SUBJECT: Addendum No. 4

REFERENCE: Invitation To Bid (ITB) for the FAA Non-Standard Taxiways at William P. Hobby Airport; Solicitation No. H06-HOUTXY-2023-019; Project No. 770

APPROVED BY: _____ DATE: _____
 DIRECTOR
 HOUSTON AIRPORT SYSTEM
 PROJECT NO: 770
 C.I.P. NO: 3-48-0110-044
 H.A.S. NO: N/A
 SHEET NO: EL510

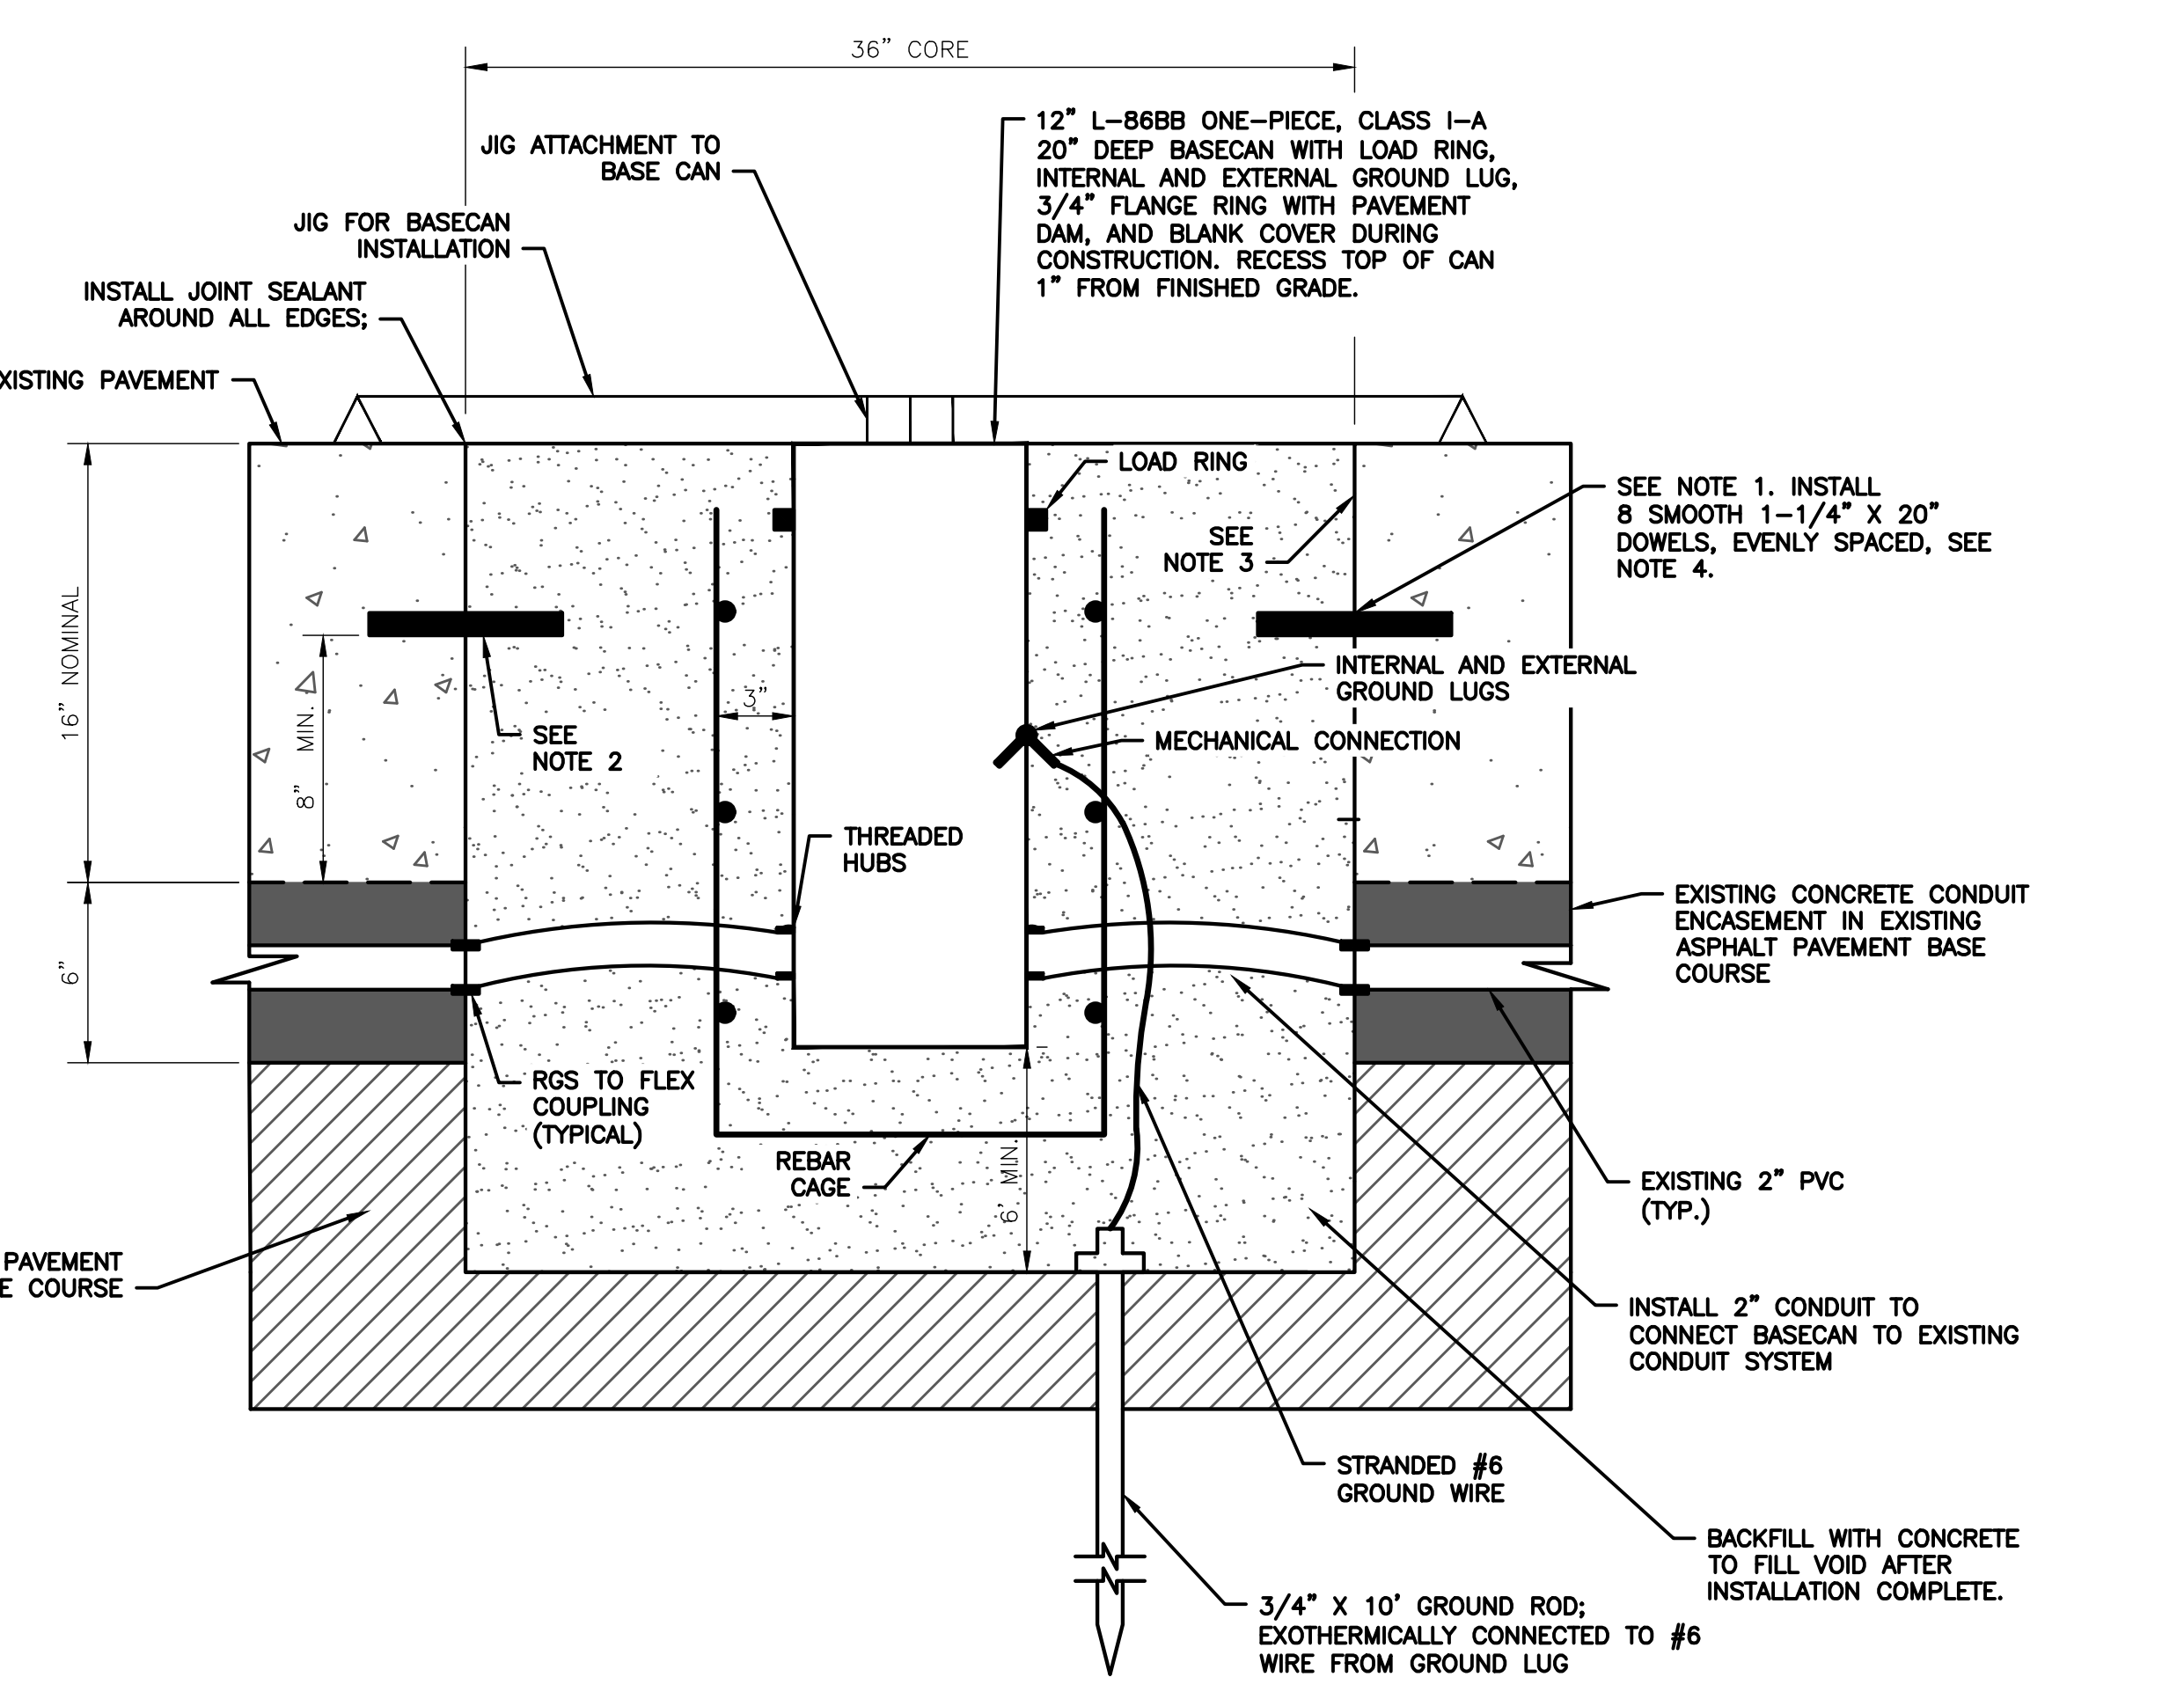
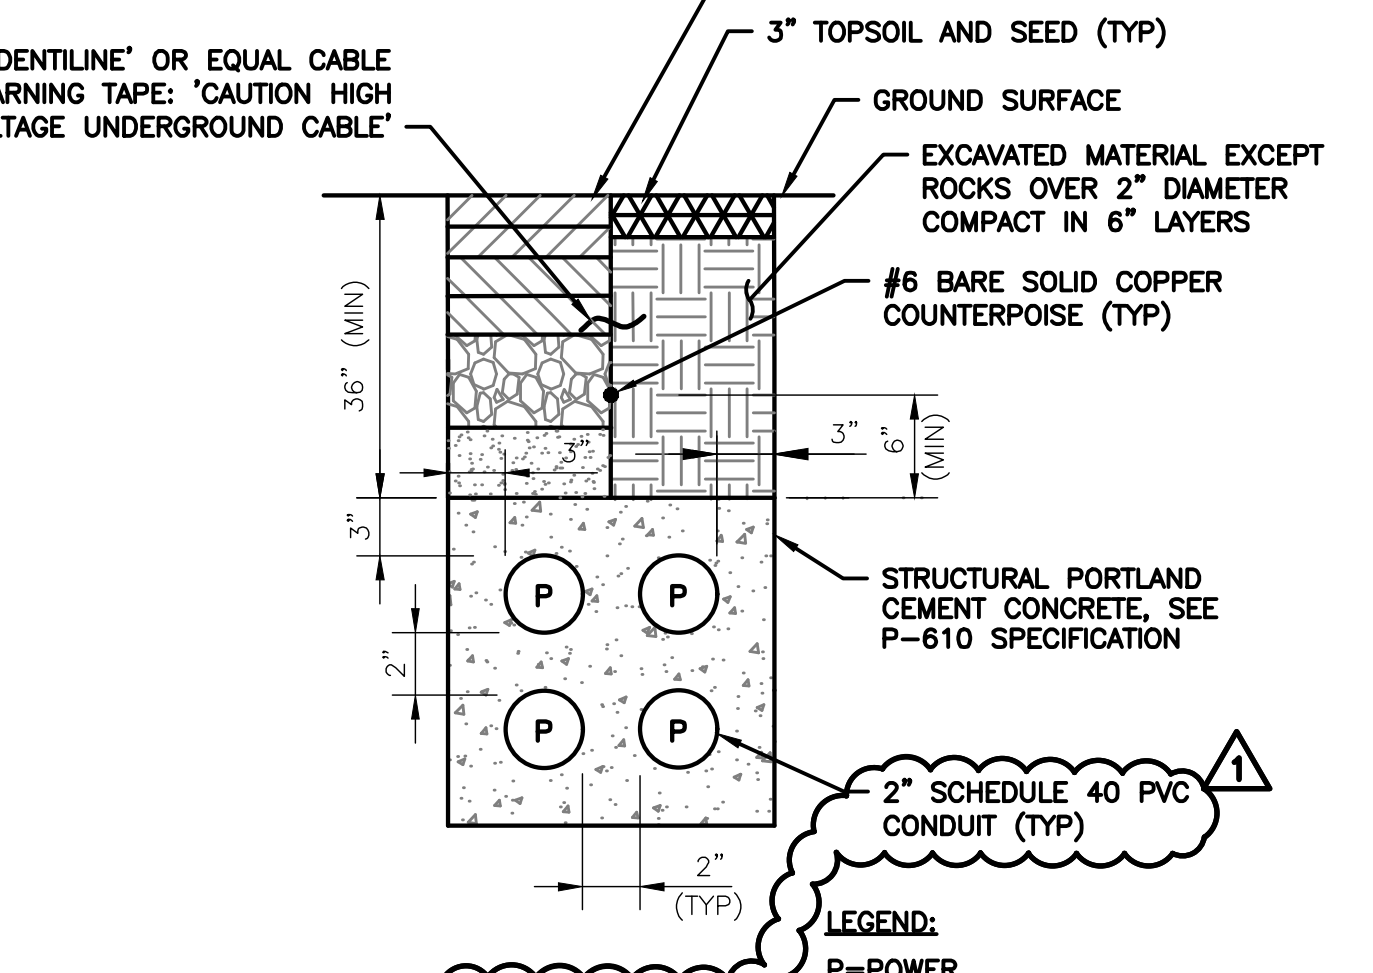
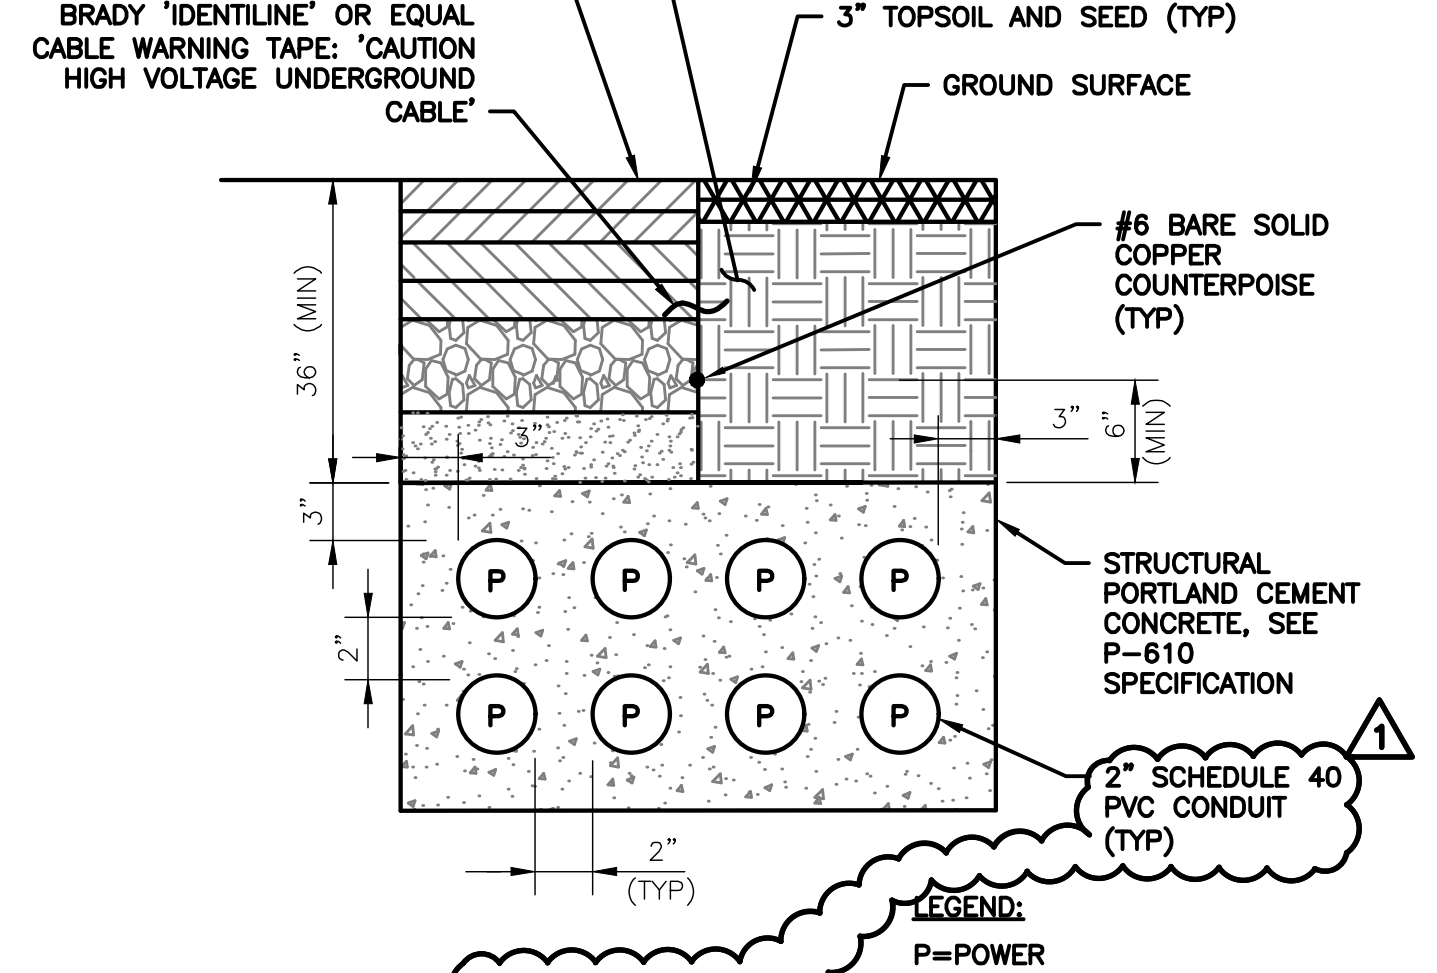
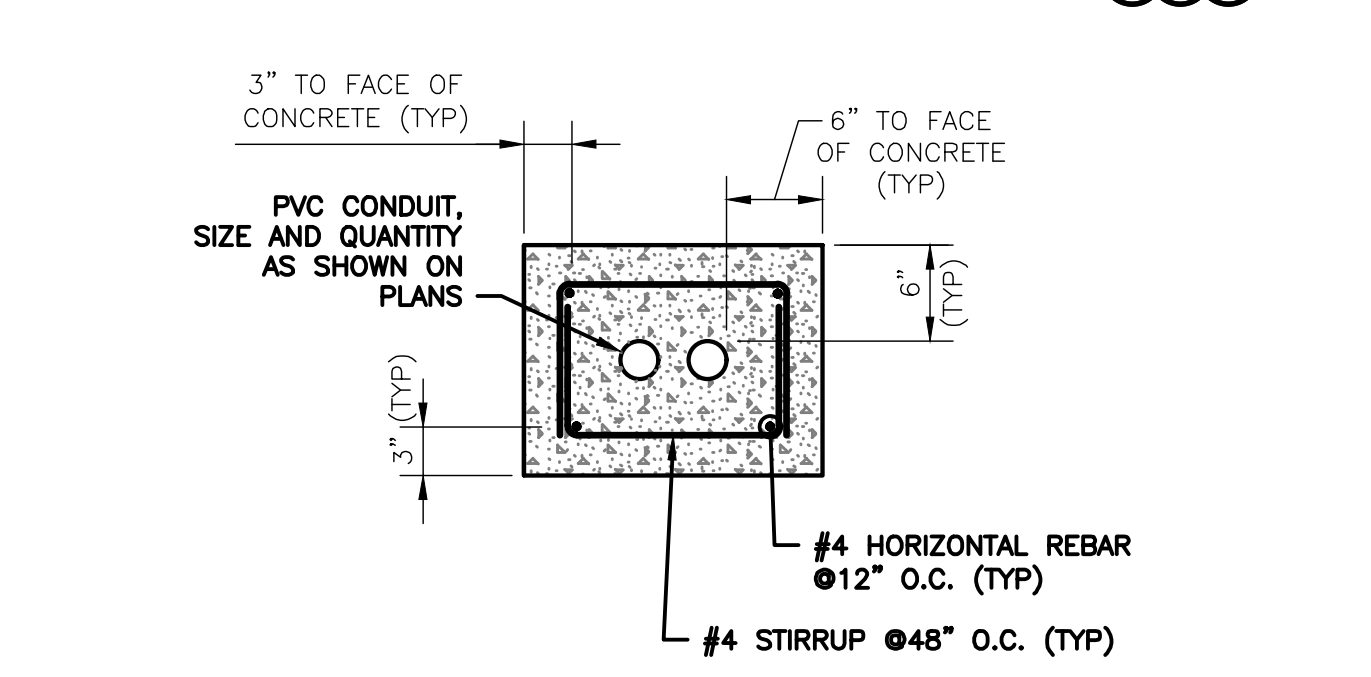
106. **Question:** See sheet EL510, detail 8. Is rebar reinforcement required for all ductbanks? If not, please specify which ductbanks this detail shall be applicable to.

Response: Reinforcing is required of any ductbanks that cross under full strength pavement and shall extend 5' beyond the edge of pavement per EL510. See updated General Note 5 on sheet E-001.
